HEGER DRY DOCK, INC

Re: Request for HEGER Certification of Dry Dock No. 2 located in BAE San Francisco, CA

The objective of this letter is to present the results of HEGER's design review. The review outlines the dry dock's limitations and notable structural deficiencies of the dock's current condition. The design review includes:

FIGURE 1 – Intact Stability Curve

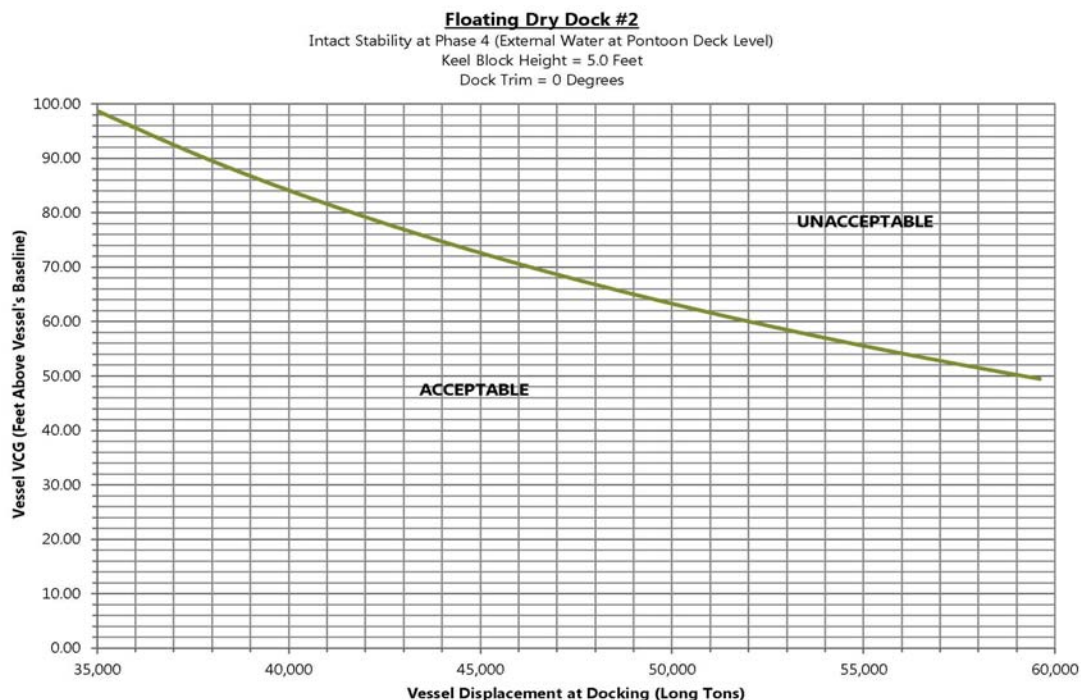
Dry Dock No. 2 was renovated in 2008 by adding six (6) 40'x12' sponsons in order to increase its transverse intact stability for docking phases 3 and 4. HEGER has developed an allowable KG versus vessel weight curve for the floating dry dock for a minimum GM of 3.28 feet as required by ABS. The stability curve is shown Figure 1 below. Plotted points that fall on or below this line are acceptable, points above are unacceptable.

FIGURE 2 - Allowable Head Pressure vs. Plate Thickness Curve

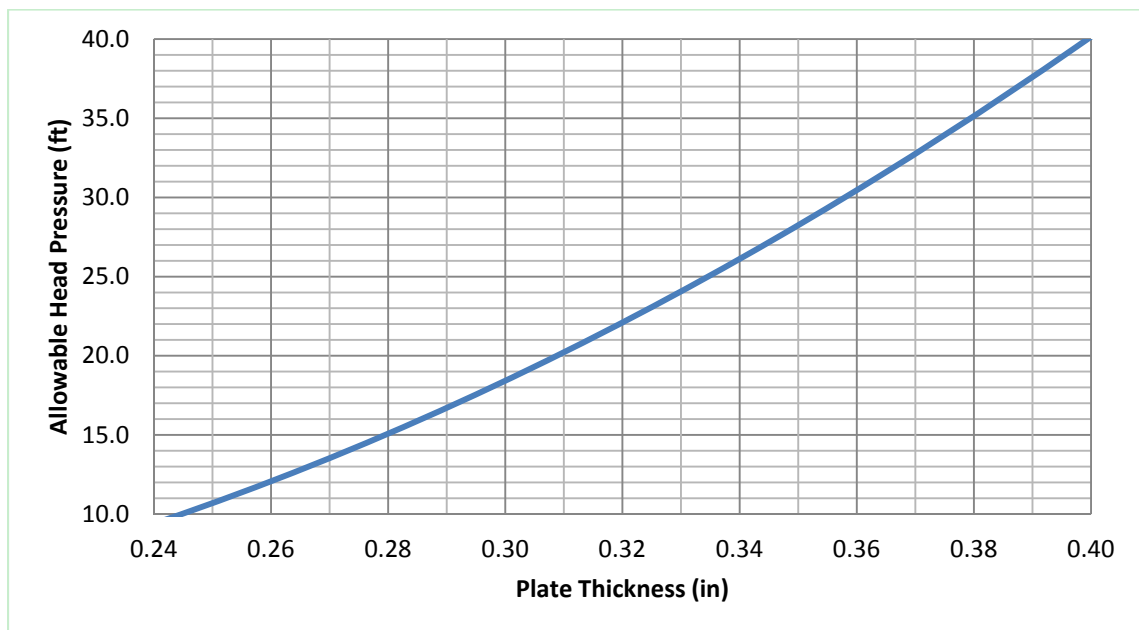
The results are as follows and are shown in Figure 2:

<u>Plate Thickness</u>	<u>Corrosion</u>	<u>Allowable Head Pressure</u>
0.35 inches	20%	28.2 feet
0.30 inches	31%	18.4 feet
0.25 inches	43%	10.7 feet

To create the chart in Figure 2, the assumption is that the angle stiffeners welded to the shell plate have 15% corrosion or less.

PLAN - PONTOON DECK - UT MEASUREMENTS
SCALE: 1/16"=1'-0" **A1**

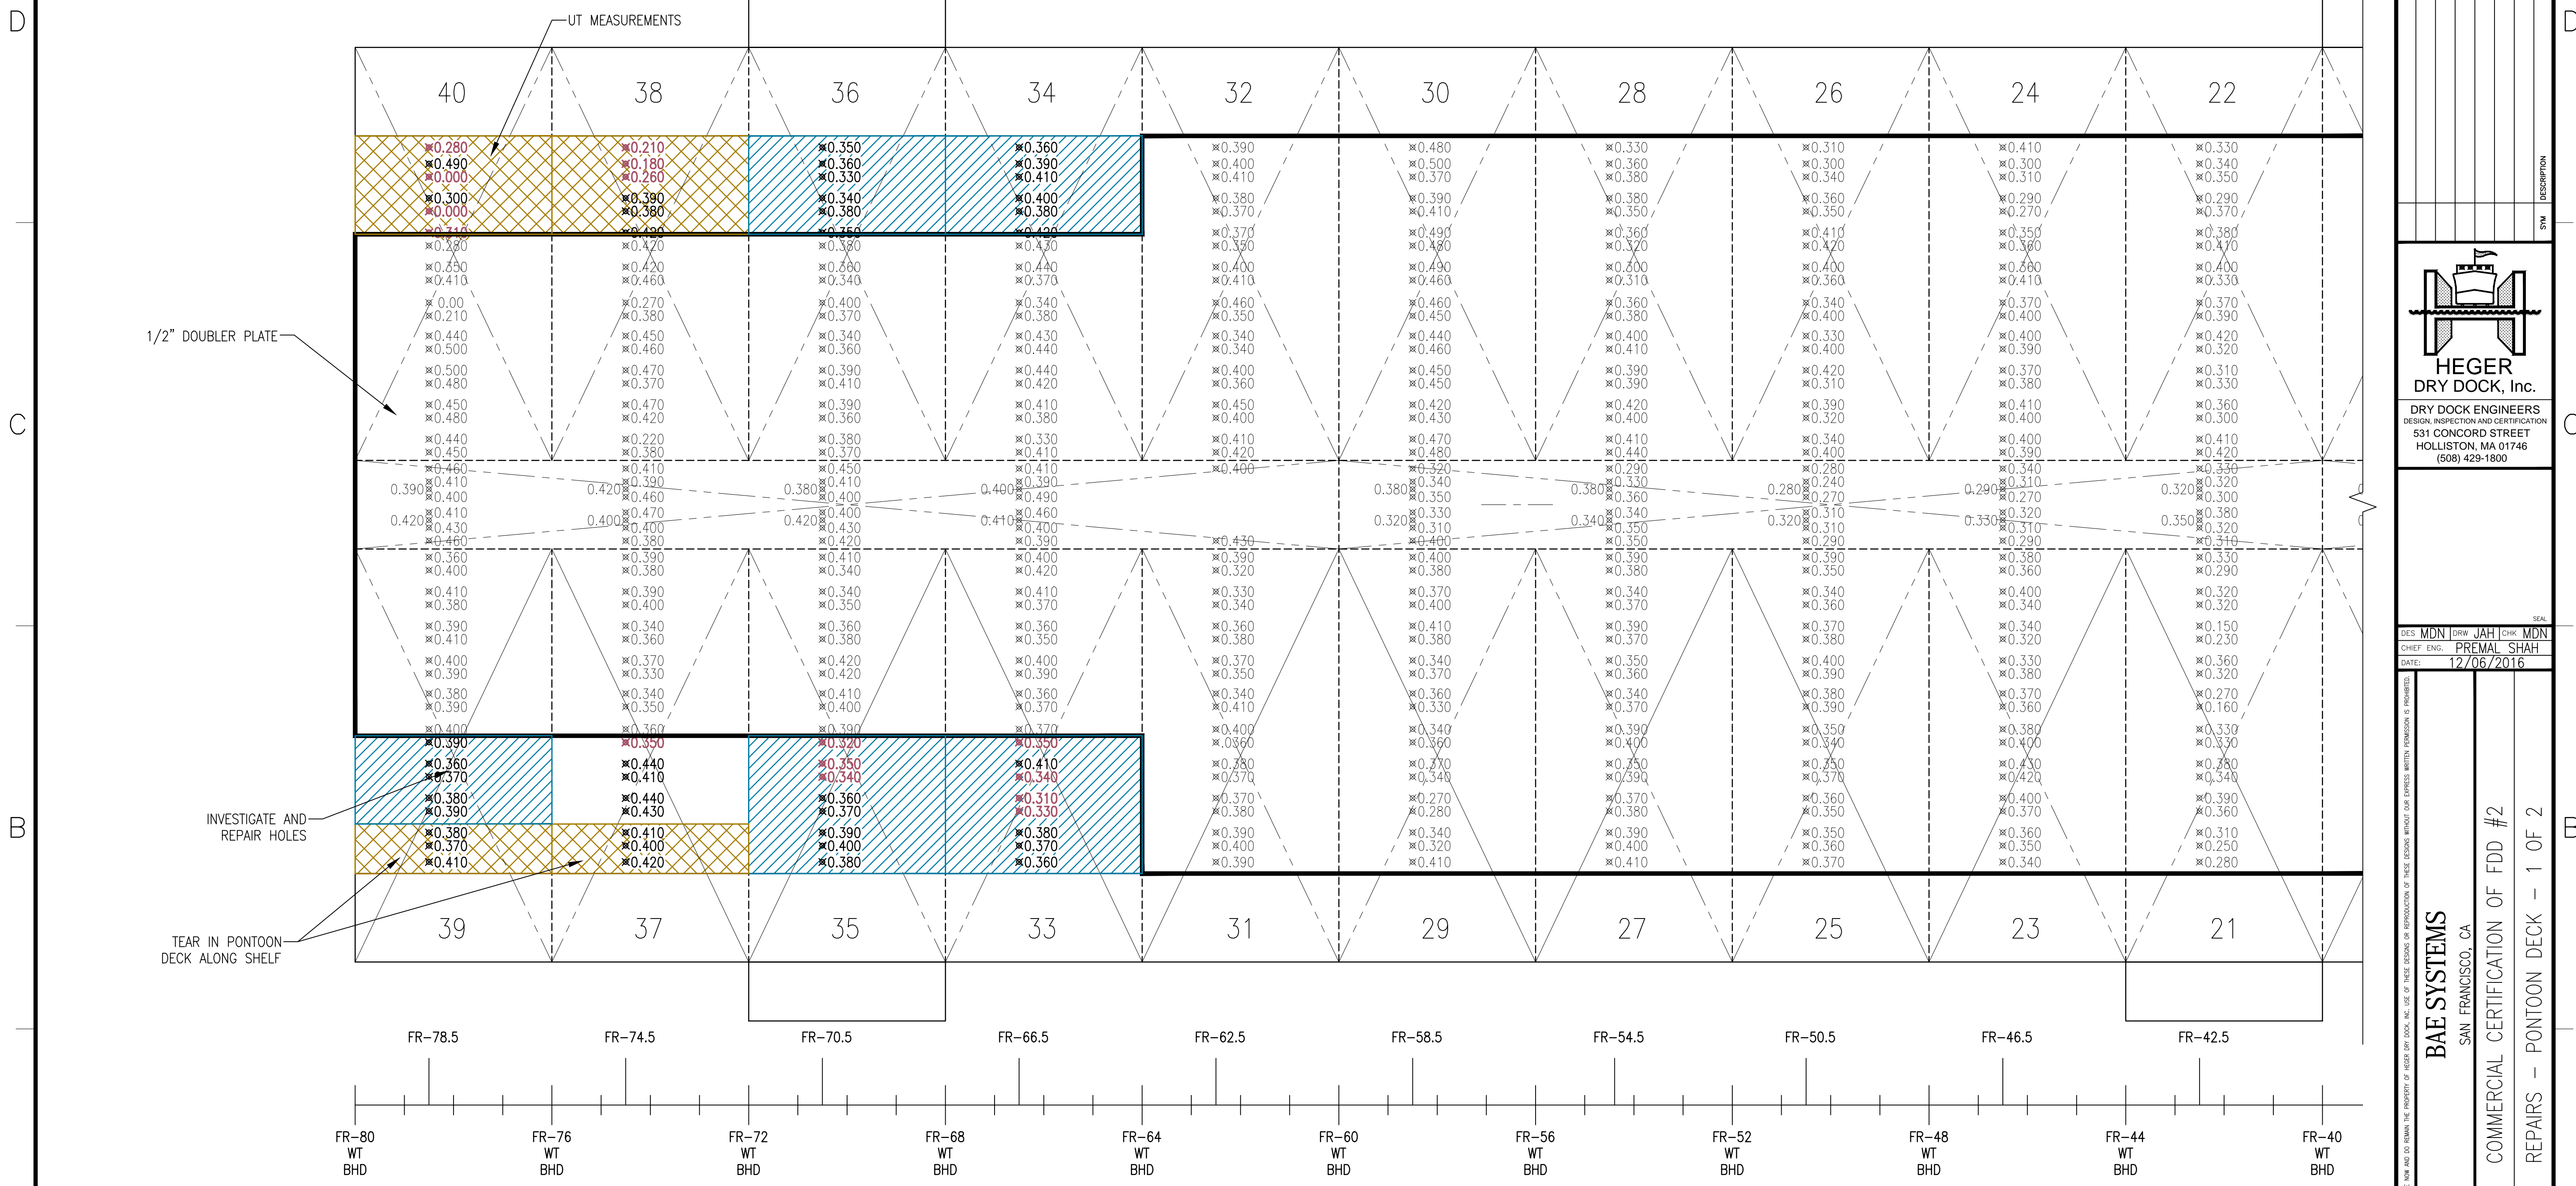
The dock's original pontoon deck is severely corroded as reflected in the most recent ultrasonic thickness (UT) measurements surveyed by International Inspection in January 2016 (see Reference 2). UT measurements were taken internally and measured the thickness of the original deck plate only.

Doubler plates have been installed on the topside of the dry dock's original pontoon deck plate over about 65% of the surface with a concentration towards the dock's centerline. The doubler plates are 1/2" in thickness and are connected to the dock's original pontoon deck plate via 2" x 6" slot welds located along transverse and longitudinal structure. These slots welds are considered essential as they provide the doubler plates with required buckling capacity. The half-inch doubler plates were installed to fortify the original deck plate as an alternative to removing and replacing the corroded plating and stiffeners.

The majority of the pontoon deck has been covered with a 1/2" doubler plate. This is not a viable long term solution for the dock. HEGER recommends a maintenance plan be developed to properly replace the corroded deck panels with insert plates. Note that the dock was originally designed with 1/2" high strength steel (yield point of 50 ksi). HEGER recommends any pontoon deck replacements be 3/4" high strength steel. Note that this may correspond to a small reduction in the lift capacity of the dock due to an increase in dock weight, but will build in additional corrosion allowance.

In the drawings listed below, all areas are generally mapped out on a tank by tank basis. It is recommended the external shell in these areas be cropped out and replaced with a fabricated insert plate to properly repair the area. In the event of small isolated holes, a doubler plate may be installed as a temporary fix.

REPAIRS - WEST OUTBOARD WINGWALL

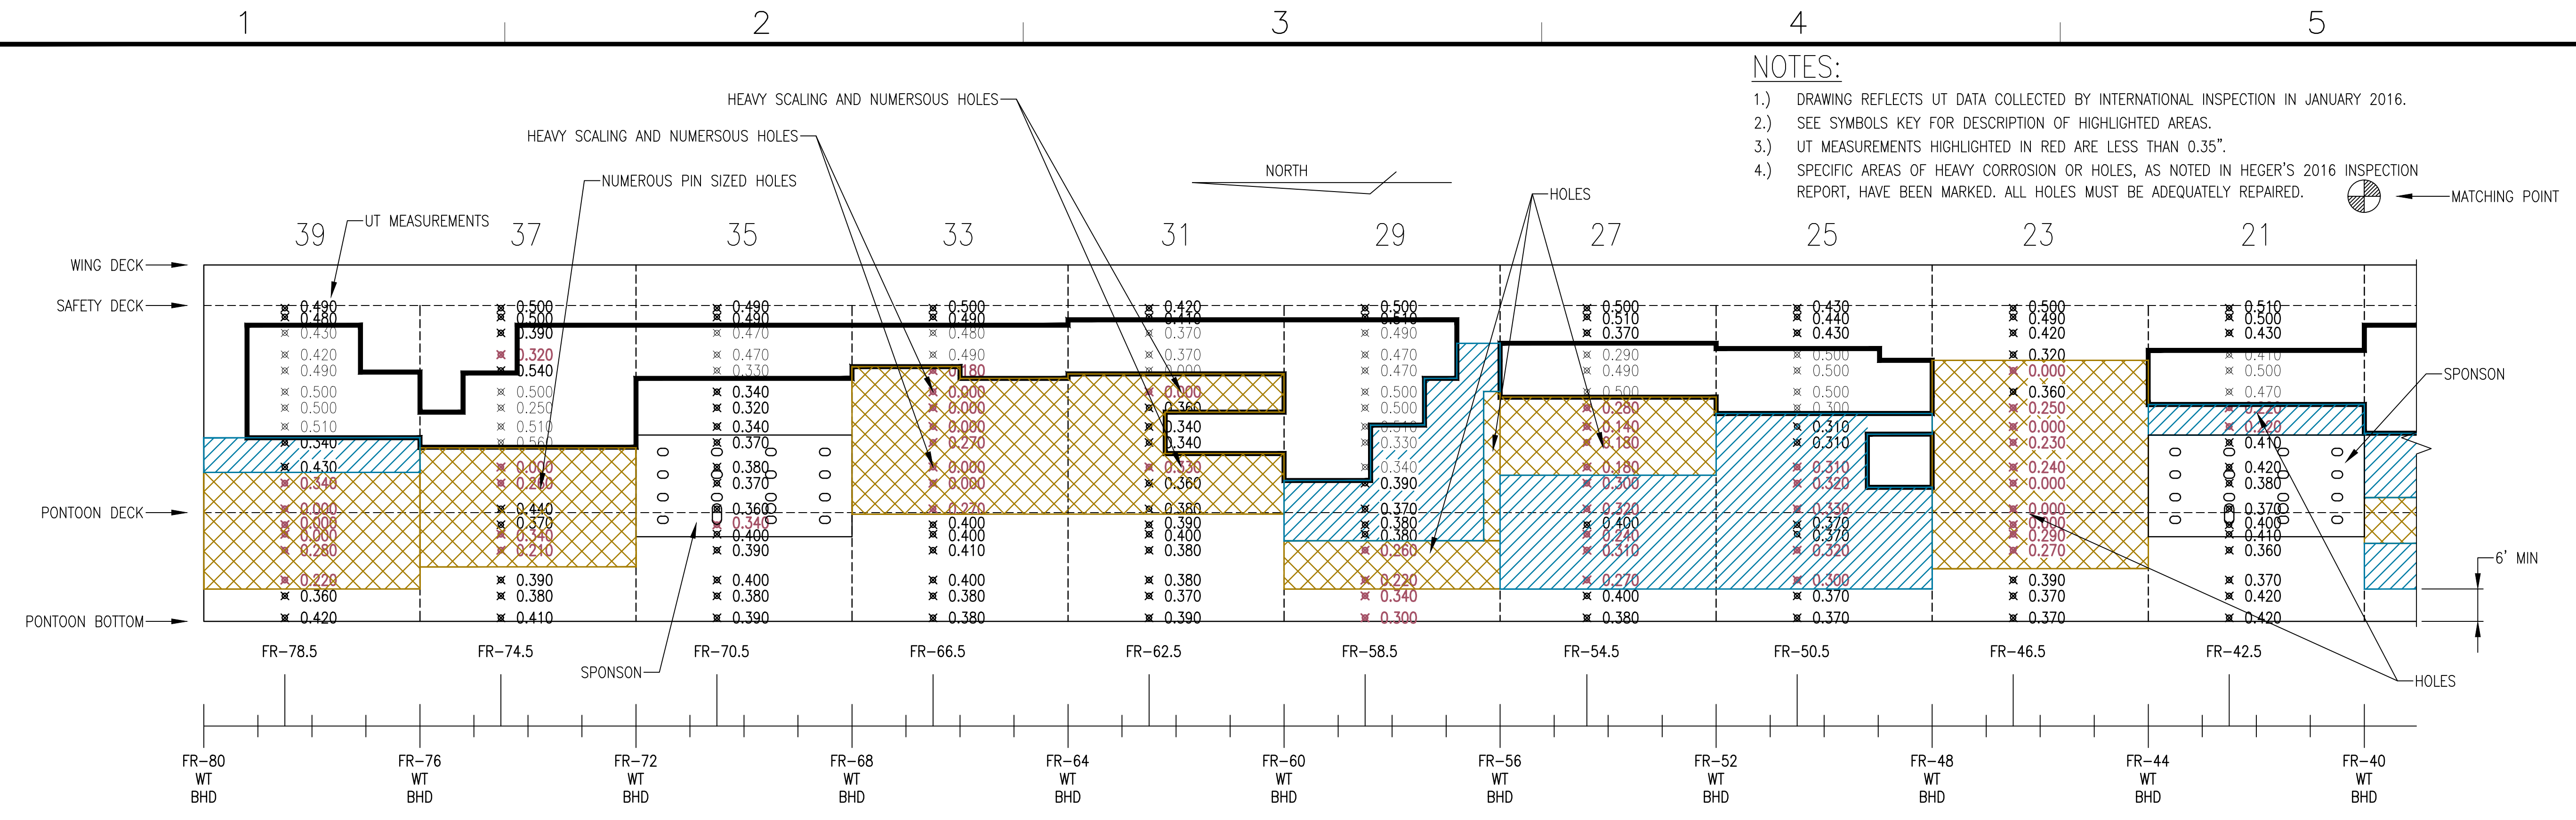
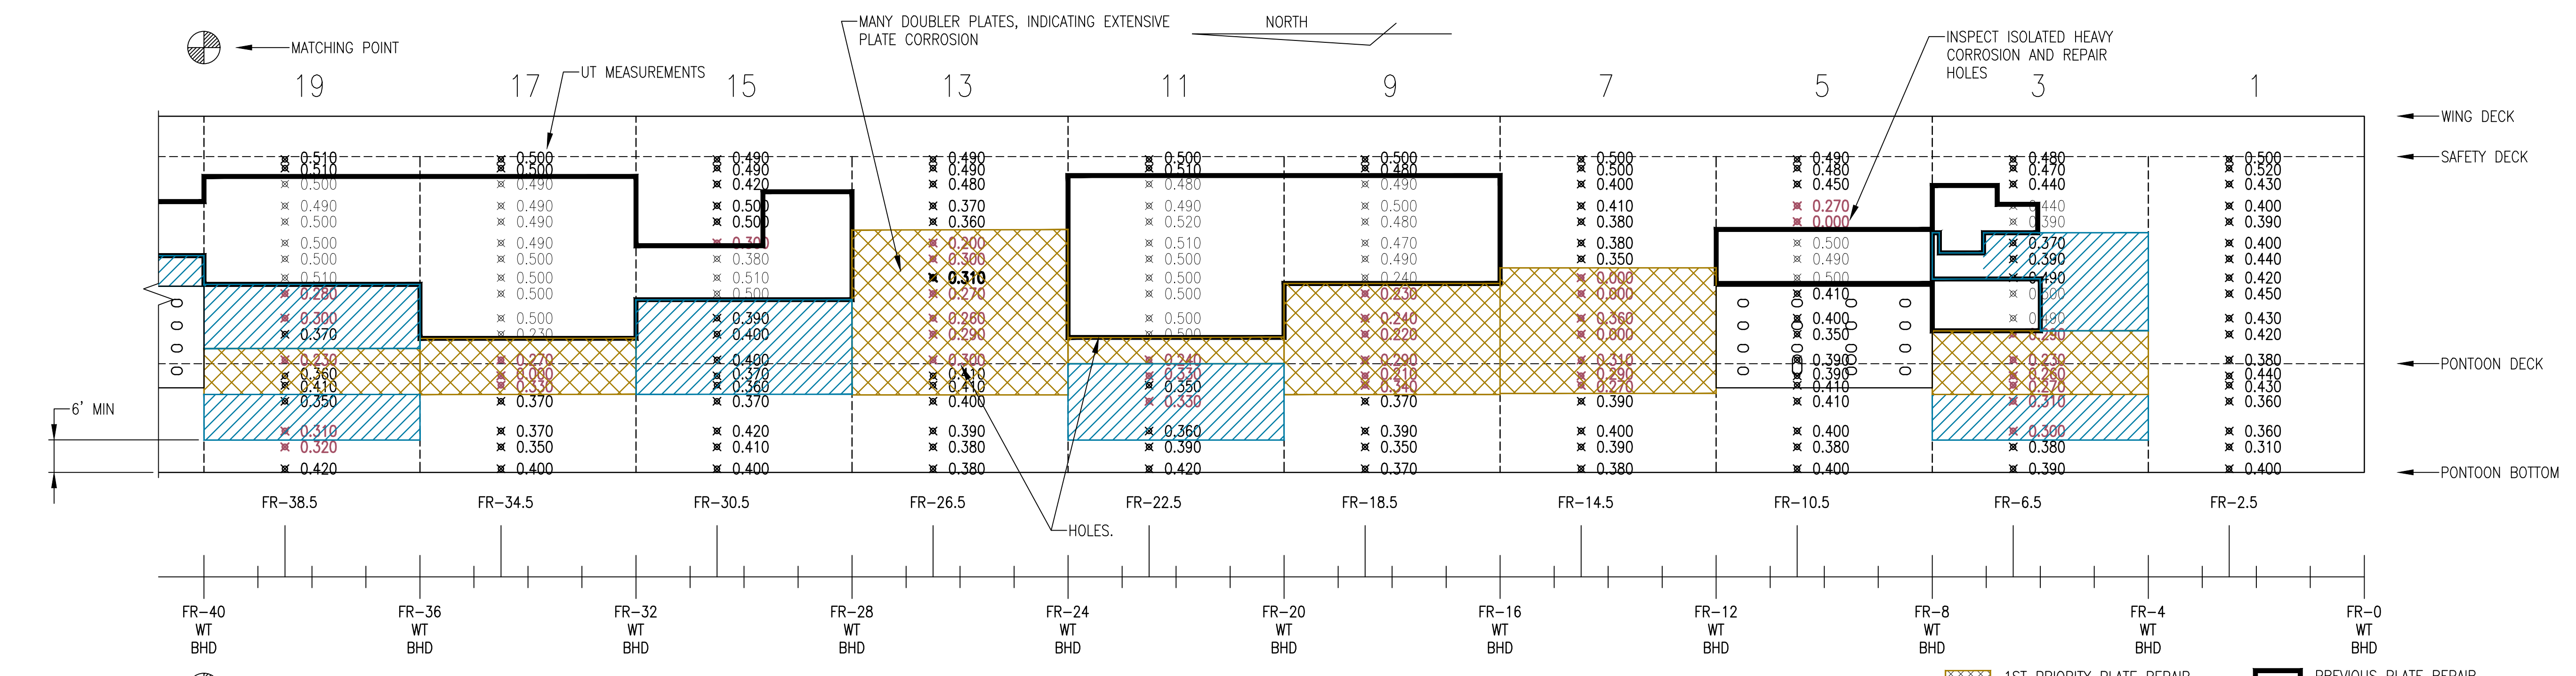
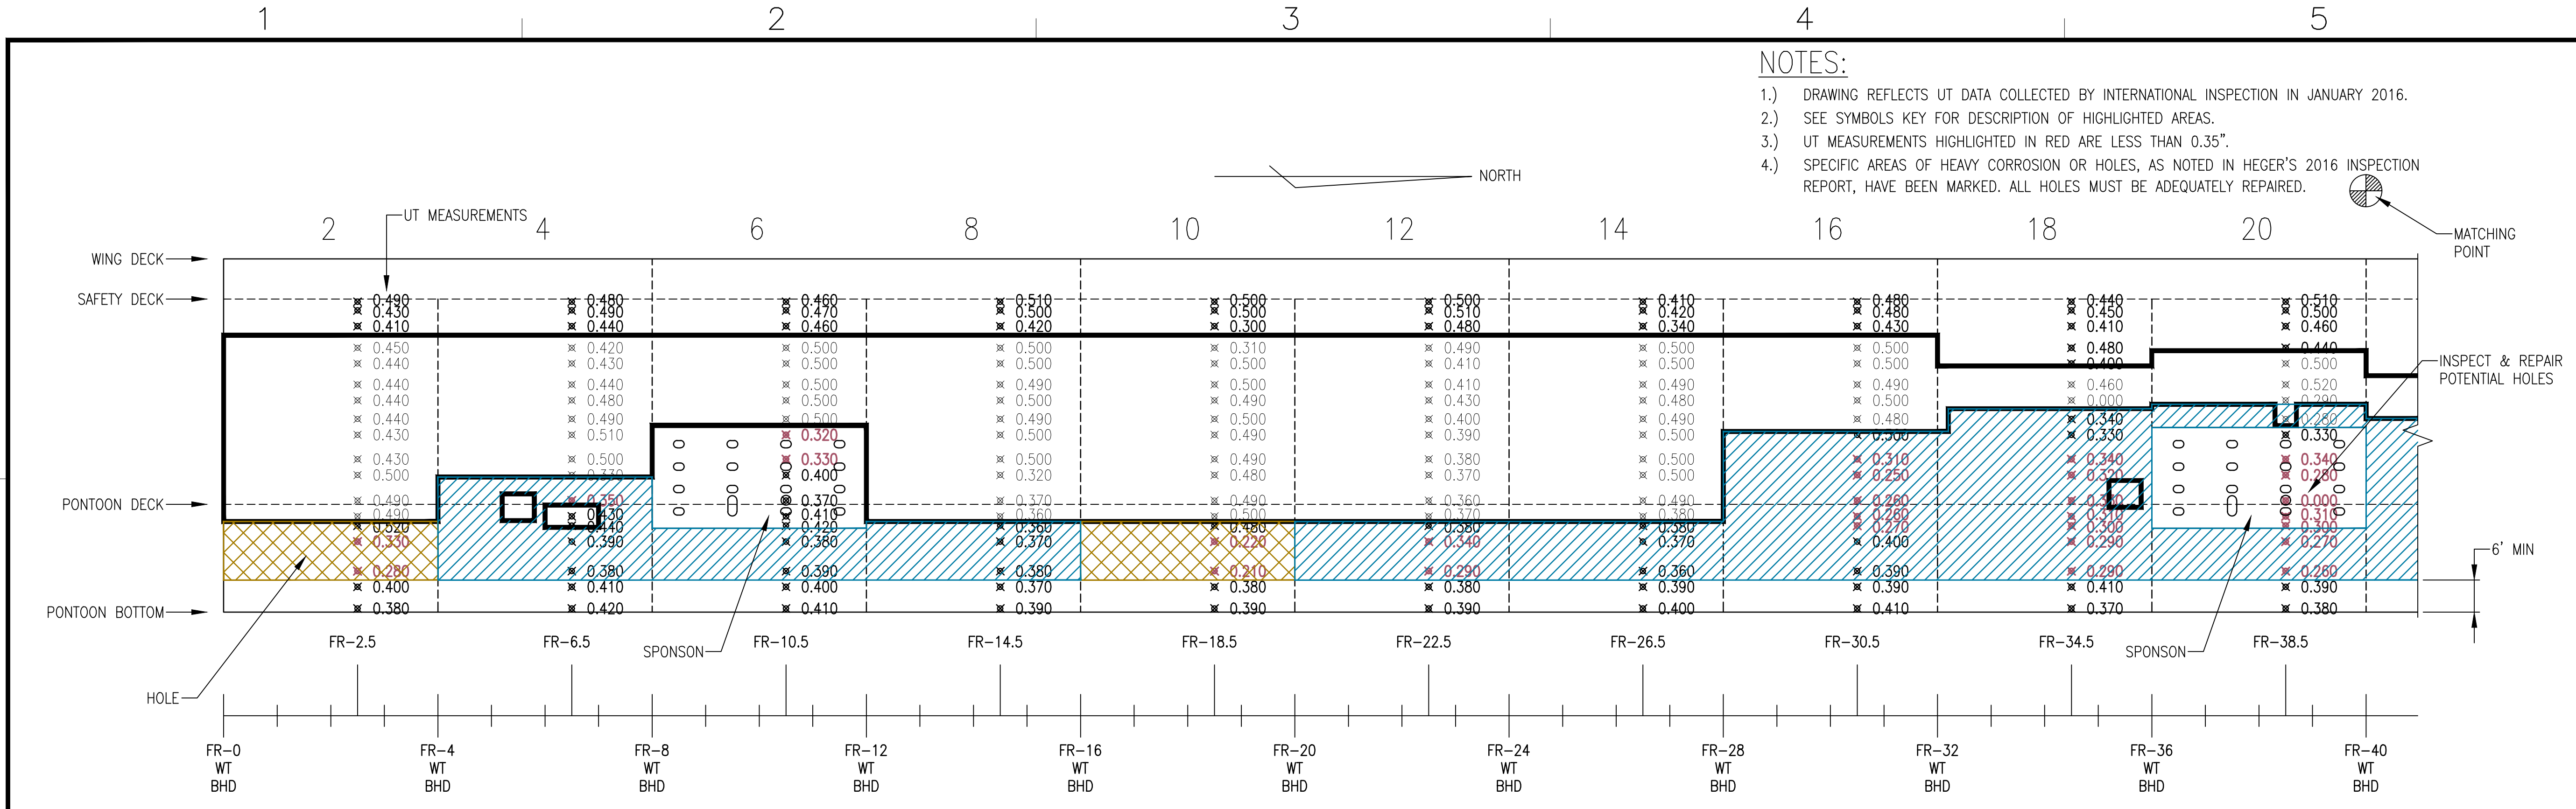
The UT survey results of the dock's external shell plating indicate areas of significant metal thickness loss. Areas of extensive corrosion were confirmed by HEGER's August 2016 visual inspection with numerous observed holes in the plating.

The majority of the external shell repairs have been made to the East and West outboard shells with about 20% of the dock's original plate panels being replaced.

HEGER's primary concern with the dock's current structural condition is the severely corroded shell plating, with number of holed-through areas. The holes, located throughout the dock, impede the watertight integrity of numerous ballast tanks and raise the following concerns:
